Docket Number:	07-AFC-06C
Project Title:	Carlsbad Energy Center - Compliance
TN #:	203313
Document Title:	Project Owner Supplemental Response to Data Request Set 3 (No. 74)
Description:	(Revised Responses to Data Requests 74.e and 74.f)
Filer:	Dee Hutchinson
Organization:	Locke Lord LLP
Submitter Role:	Applicant Representative
Submission Date:	11/4/2014 3:31:57 PM
Docketed Date:	11/4/2014

Re: Carlsbad Energy Center Project Petition to Amend (07-AFC-06C)
Supplemental Response to Data Request Set 3 (No. 74)
(Revised Responses to Data Requests 74.e. and 74.f)

Supplemental Response to Data Request 74

(Revised responses to Data Requests 74.e. and 74.f)

FIGURE DR74-1
CECP Oblique Rendering
Carlsbad Energy Center Project
Carlsbad, California (07-AFC-06C)
Petition to Amend

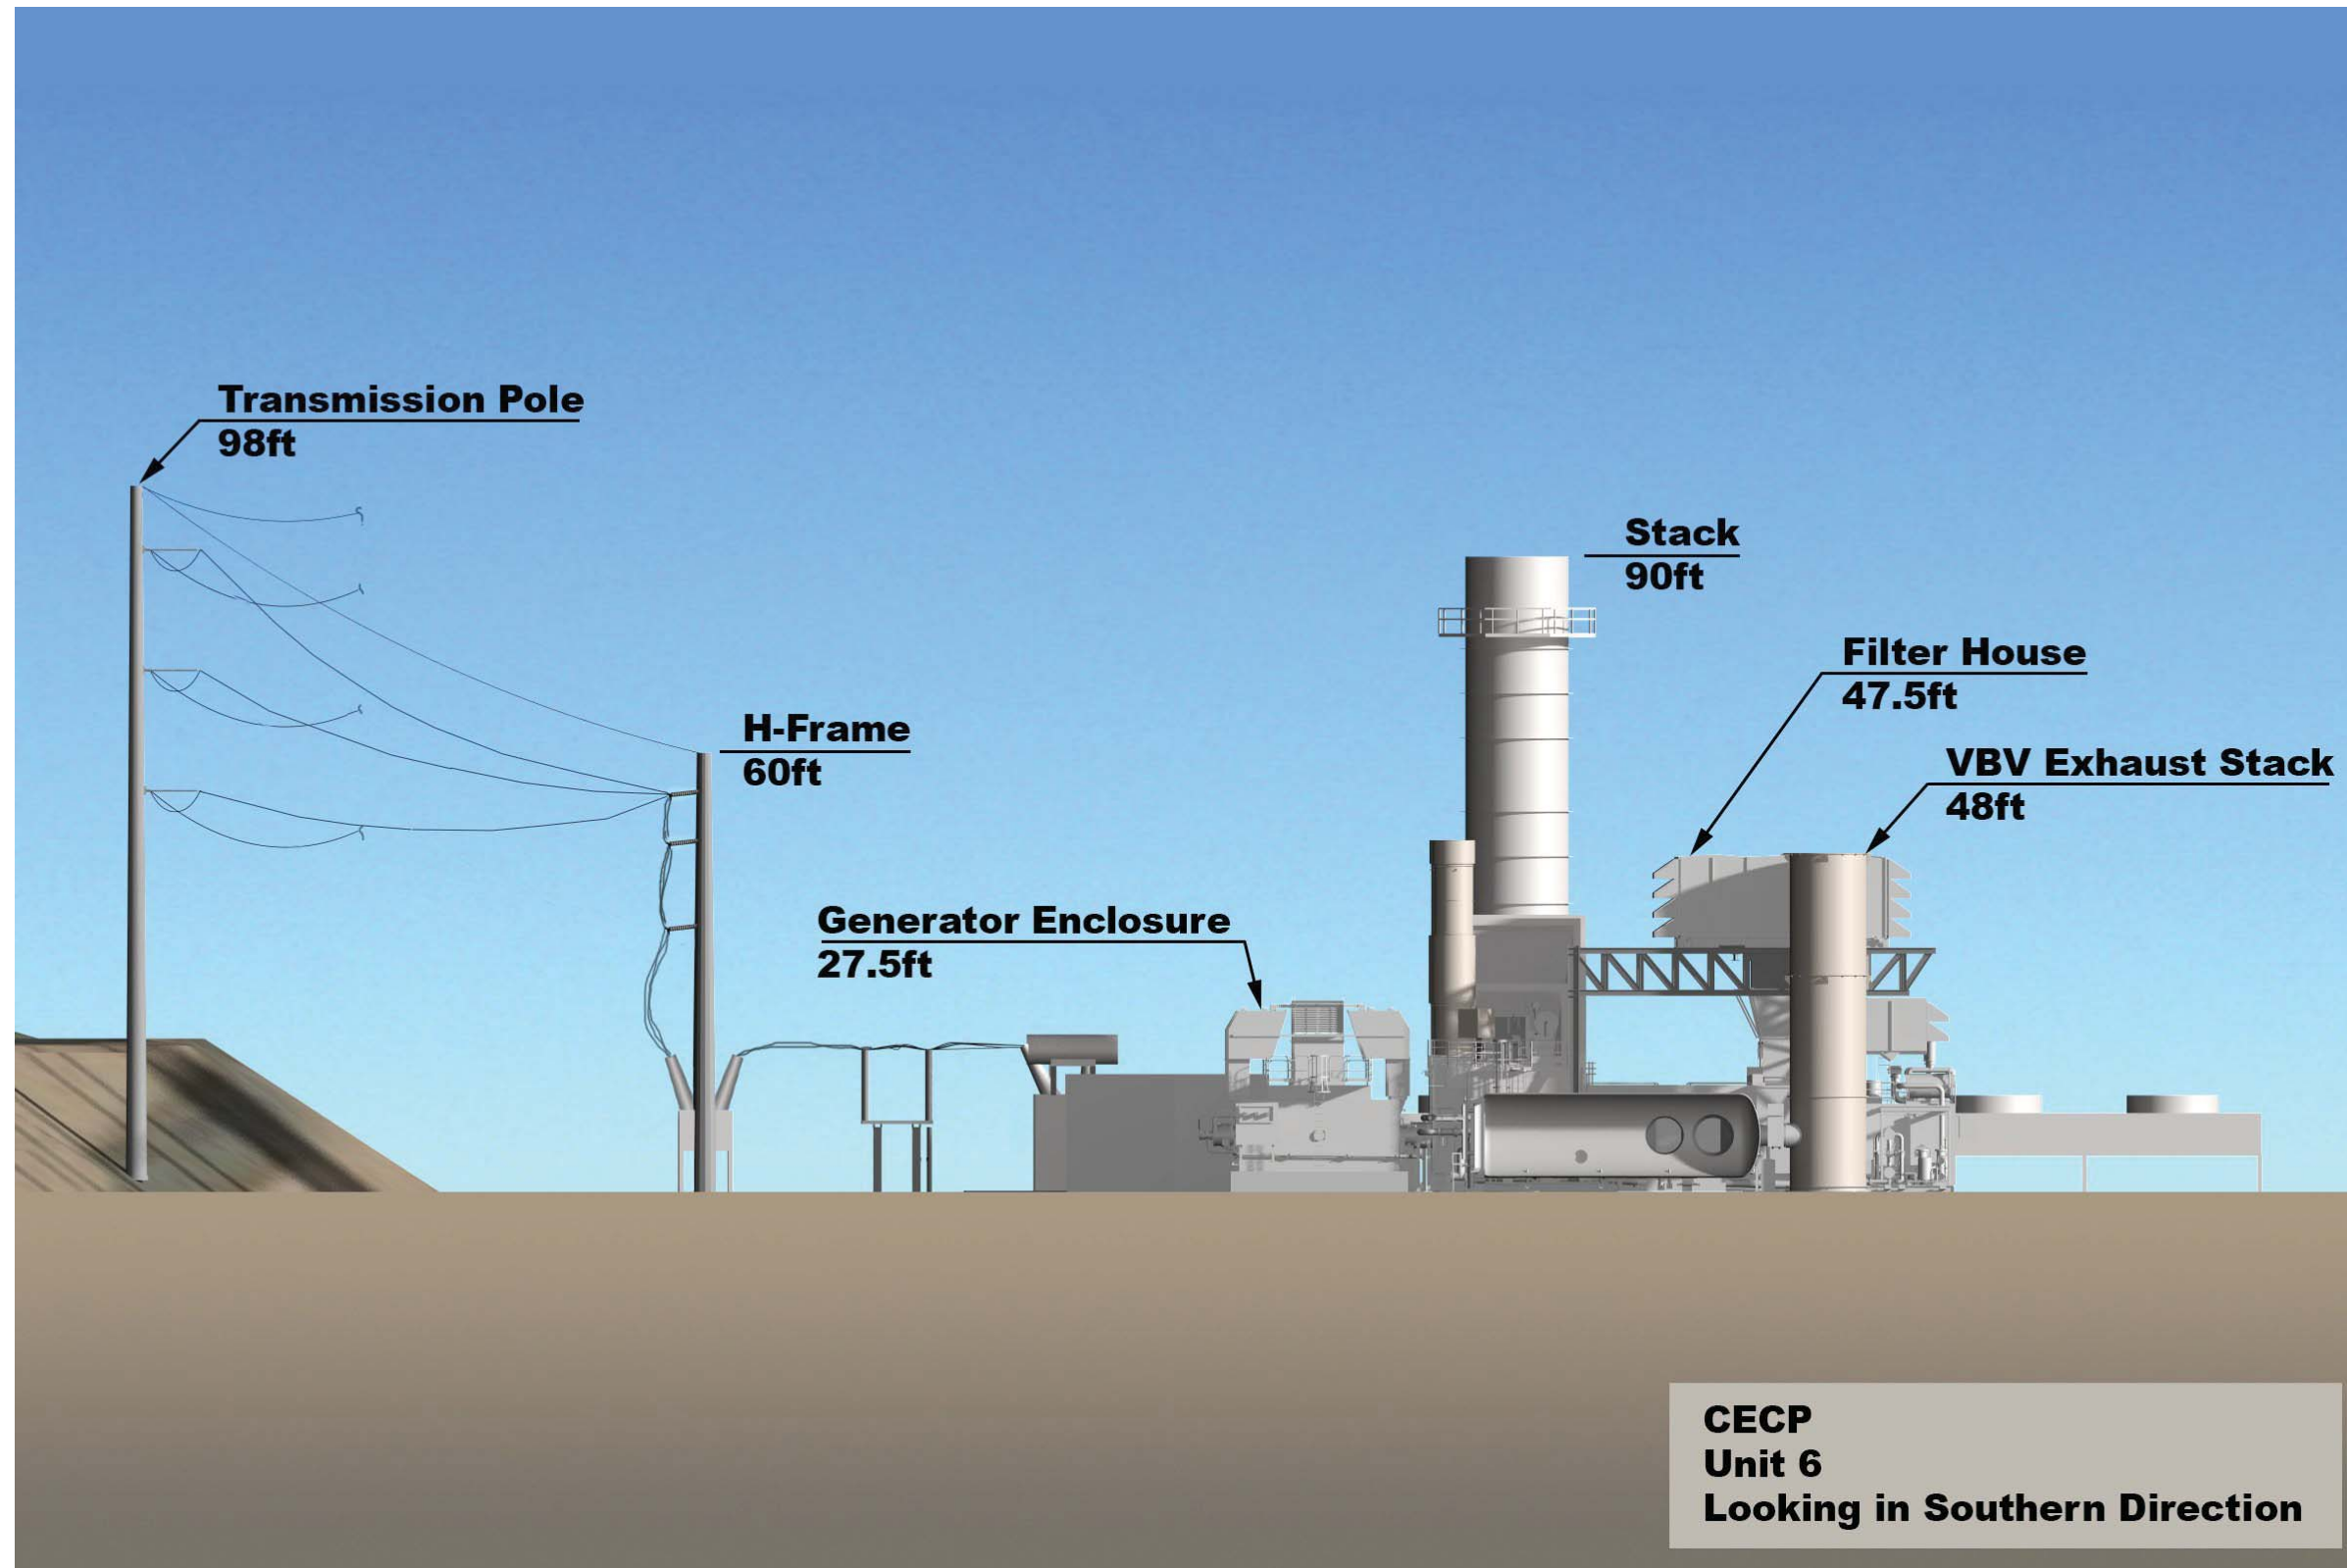
- Please provide detailed 3-phase diagram(s) (plan and side view) showing positions of the two H-pole take-off structures (refine Figure DR 22-2) for the gen unit outlet lines in each amended CECP switchyard, the transitions between gen outlet lines and gen tie line(s) in the line dead end pole.

The new Figure DR74-1 is also generally responsive to requests from members of the community and other parties to see what the project equipment and components would like if they were actually visible. Figure 74-1 shows a three dimensional "birds eye" view of the generation project looking down into the bowl from above.

74e. A revised Figure DR74-1, containing a revised description of the Figure is hereby provided.
